Committee: Cabinet Member Report

Subject: Statutory Consultation – Proposed speed humps – Robinson Road

Robinson Road, Colliers Wood Proposed Traffic Calming (Road Humps)

STATUTORY CONSULTATION REPRESENTATIONS & OFFICER'S COMMENTS

NEWSLETTER & PLAN APPENDIX 1

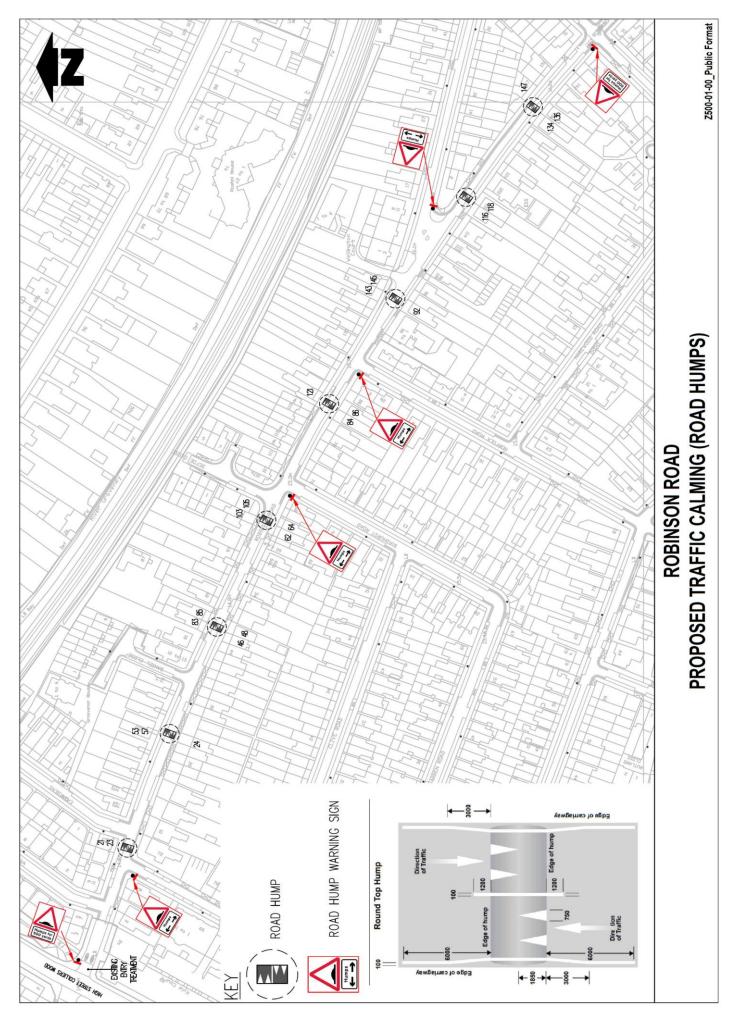
I am writing in relation to the proposed traffic calming (road humps) measures on Robinson Road, Colliers Wood. Whilst I am in full support of the implementation of this measure, I can't help but feel that it would be beneficial to install a road hump prior to the intersection between Robinson Road and Park Road. It is this route that drivers will usually take to bypass the High Street and there will be nothing in place to prevent the the continuation of this 'rat run' between no. 1 and no. 23 Robinson Road, and drivers turning on to Park Road. As the owner and resident of 11 Robinson Road, opposite this junction, I often observe cars driving at speed across this short distance, dangerously cutting off the corner and ultimately driving down the wrong side of the road when entering Park Road. I would greatly appreciate this suggestion being taken into consideration and look forward to the implementation of this in due course.

We are residents of Robinson Road in Colliers Wood and we are writing to make a representation against the proposed traffic calming measures on Robinson Road. Whilst we believe there should be some measures put in place to reduce traffic speed, the current proposal of 8 speed humps does seem a bit excessive. Please see information for representation below:

Some traffic calming measures would be useful to reduce traffic speed, particularly at the end of the road towards Devonshire Road (eastbound) where the road narrows. But 8 speed humps appears a bit excessive. 4 humps would be more proportional given the road doesn't have that much traffic on it.

The construction, design, number of humps and spacing is in line with DfT guidance. Doubling the spacing will fall outside the guidelines for this 20 mph road and would not reduce speed of traffic.

Drivers are likely to drive at higher speed between each feature, whilst only slowing down on approach to each feature. See comments in ref 005 for braking and emissions.
